Access Compliance Report

Public Rights-of-Way

(Curb Ramps)

Intersection ID: 16208	Main Street: MARVIN_RD	Cross Street: BILLINGSLEY_RD	Location: NW
ADA ID: 7514E03E1D19	Ramp Type: PerpDiag	Initial Pass/Fail: Fail	Overall Compliance: No
			Severity Score: 21.25

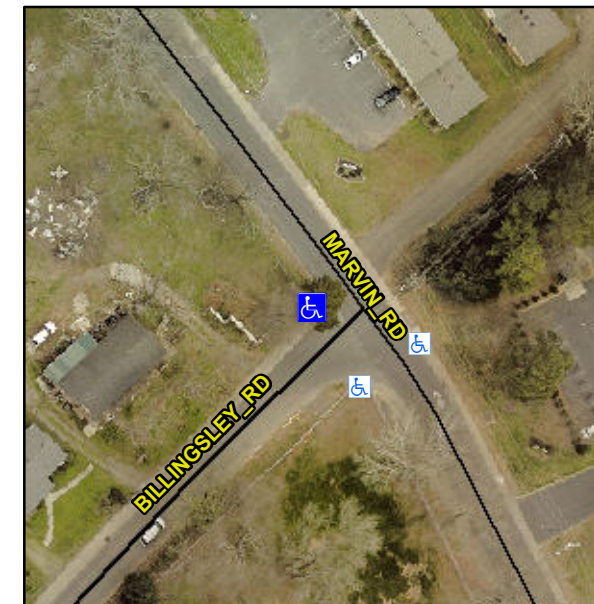
Not Found, R304.5.1, R304.2.2

Compliance	Description	Data	Compliance	Description	Data
N/A	Ramp Length (in)	60.0	No	Ramp Slope (%)	10.0
No	Ramp Width (in)	37.5	Yes	Ramp XSlope (%)	1.8
N/A	Flare Type LT	N/A	N/A	Flare Type RT	N/A
N/A	Flare Slope LT (%)	N/A	N/A	Flare Slope RT (%)	N/A
N/A	Flare Traversable LT?	N/A	N/A	Flare Traversable RT?	N/A
N/A	Landing Length (in)	N/A	N/A	DWS Provided?	N/A
N/A	Landing Width (in)	N/A	N/A	DWS Contrast?	N/A
N/A	Landing Slope (%)	N/A	N/A	DWS Length (in)	N/A
N/A	Landing X Slope (%)	N/A	N/A	DWS Full Width?	N/A
N/A	Landing Curb? (Y/N)	N/A	N/A	DWS Offset (in)	N/A
N/A	Shared Landing?	N/A			
N/A	Gutter Ponding?	N/A	N/A	Gutter Slope (%)	N/A
N/A	Gutter Lip Ht (in)	N/A	N/A	Gutter X Slope (%)	N/A
N/A	Painted X Walk1?	No	N/A	Painted X Walk2?	No
	X Walk 1 Direction	To SE		X Walk 2 Direction	To NE
N/A	X Walk 1 Width (in)	N/A	N/A	X Walk 2 Width (in)	N/A
	X Walk 1 Slope (%)	7.3		X Walk 2 Slope (%)	1.9
	X Walk 1 X Slope (%)	1.2		X Walk 2 X Slope (%)	4.7

Remove & Replace Curb Ramp With Two New Directional Ramps or Equivalent.
